IEEE 1722a Timestamp Extension Proposal

Amanda Ge

Marvell Semiconductor, Inc.

4/18/2012

Figure 6.1—IEC 61883/IIDC common header fields

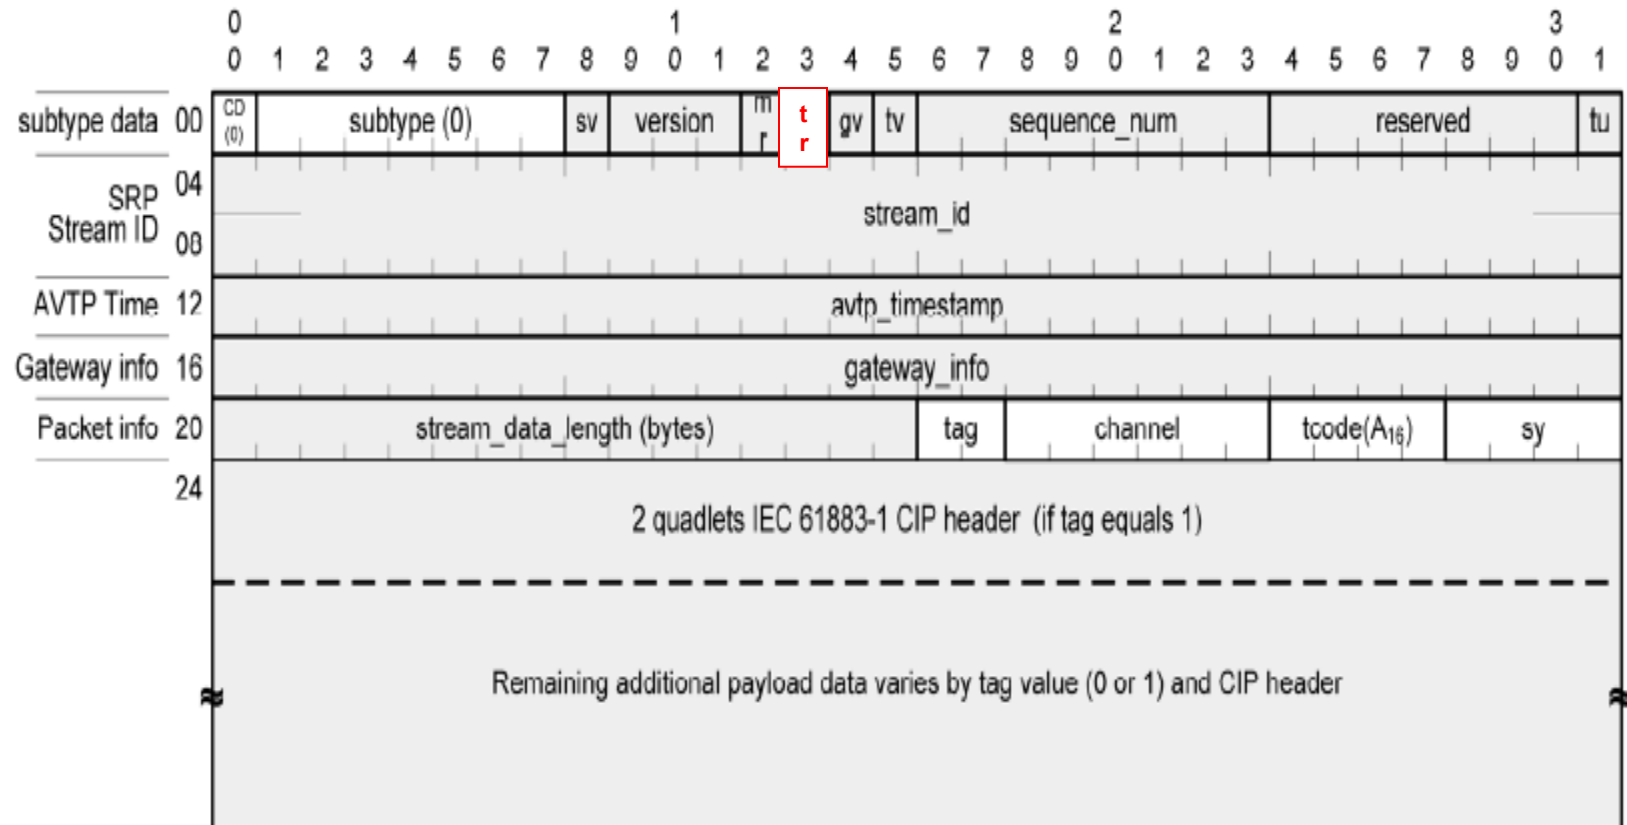
- No change on 1722 v0 header
- Add 1 bit timestamp_resolution (tr) field to 1722 v1 header relevant subtypes, where value 0 = 1 ns; 1 = 10 ns
- The timestamp resolution applies to both avtp_timestamp and event_timestamp fields.
